# Technical Bulletin

## OP351 & OP382

### Oil Pumps for Mercedes Benz and Jeep

TB0039

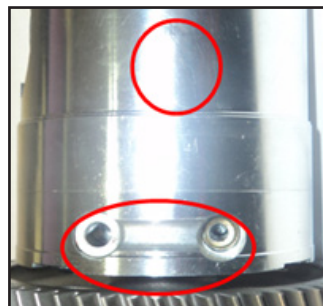
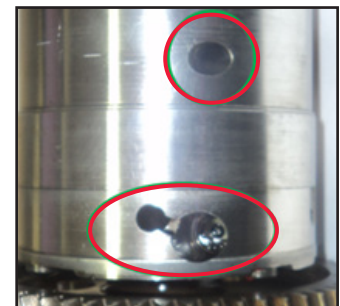
If the wrong version of the oil pump is installed, it could cause issues with the supply of oil to the engine due to the relevant Oil Galleries being in the wrong location for the engine block.

The main differences between both the oil pumps in terms of design is position and design of the oil galleries.
